MIL-T–48460B (AR)
AMENDMENT 2
20 JUNE 1998
SUPERSEDING
AMENDMENT 1
29 APRIL 1988

MILITARY SPECIFICATION

TACHOMETER, RATE, COMPUTER: 11732700

Figure 2. Output load for ripple measurement.

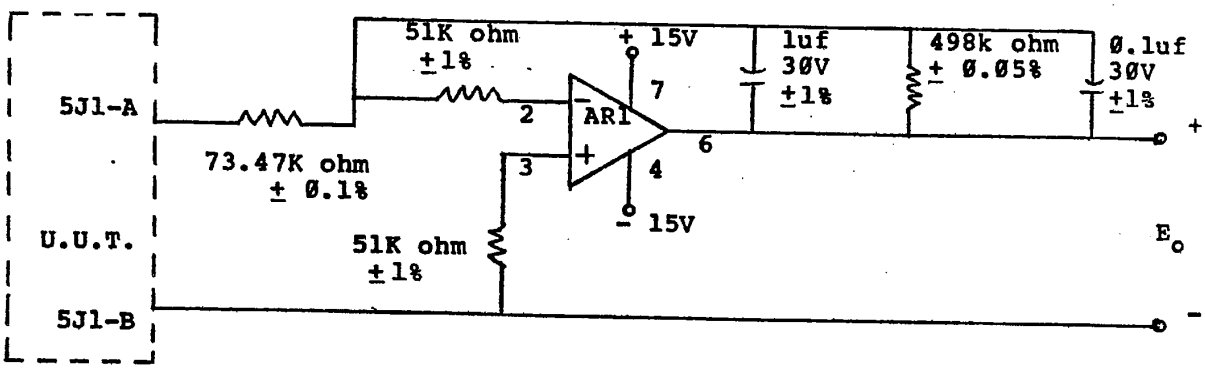
Figure 2: Delete in its entirety and substitute:

NOTES: Resisters per MIL-R-55182
Capacitors per MIL-C-83421
AR1 is LM10H/883

FIGURE 3. Positive shaft rotation.

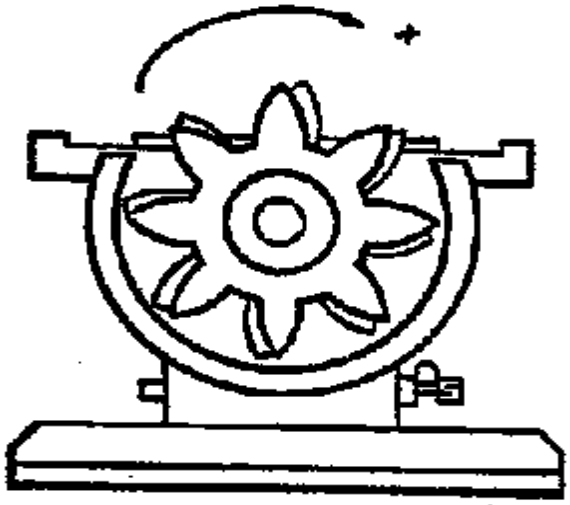
* Figure 3: Delete in its entirety and substitute the following:
